## ELECTRICAL PROTECTION OF BURIED PLANT

**Purpose:** The purpose of this addendum is to clarify references to gas tube arresters to bring these references into alignment with TE & CM Section 823, as well as to discuss protection practices for "crosstalk screened cable facilities."

**Purpose:** The purpose of this addendum is to add the requirement to bond metallic buried plant housings to vertical pole ground wires on power poles if the buried plant housing is mounted on the power pole or within a man's reach of the power pole. If they are not bonded together the vertical pole ground wires that are connected to multigrounded neutral conductors may become energized during power fault conditions and thereby create a shock hazard to anyone simultaneously contacting the vertical pole ground wire and the buried plant housing.

FIGURE 1  
Protection at Exposed Aerial Insert in Buried Plant Using Fuse Links

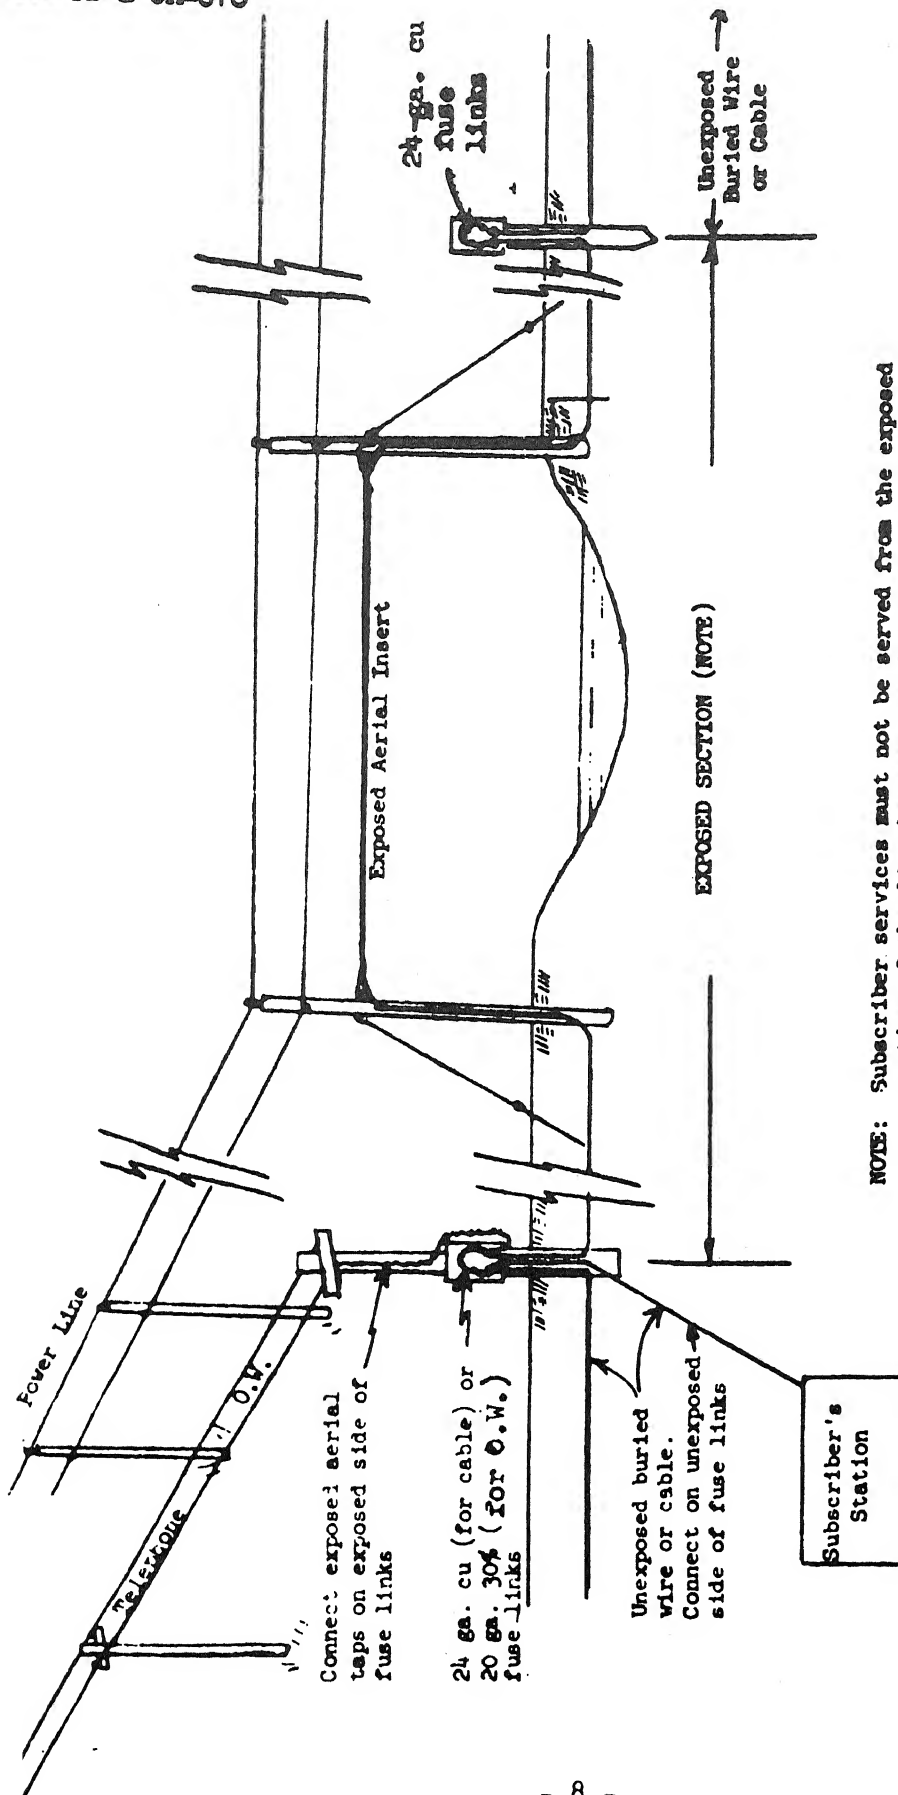
4.123 If the conductors of both the buried plant and the aerial insert are larger than 24-gauge, isolation of the exposed aerial insert should be accomplished by providing 24-gauge copper fuse links between the aerial insert and the buried portions of the cable. These fuse links should be applied at both ends of the exposed insert, as shown in Figure 1. In order to minimize the cost of isolating aerial inserts, the 24-gauge links should usually be installed in terminal housings that are required for other purposes at points nearest to each end of the aerial insert. Color-coded 24-gauge leads at least 8 inches long should be spliced in series with each conductor of the cable between the end of the buried portion of the cable and the adjoining end of the aerial insert. The color code must be preserved. If subscribers' services or buried wire branch tap leads are distributed from the buried plant terminal housings involved, they should be connected to the unexposed side of the fuse link. Exposed aerial taps should be connected to the exposed side of the fuse links. The shields of all cables or wires appearing in the buried plant terminal housings should be bonded together and grounded to the same ground electrode to which the support strand is grounded. A typical exposed aerial insert is shown in Figure 1.
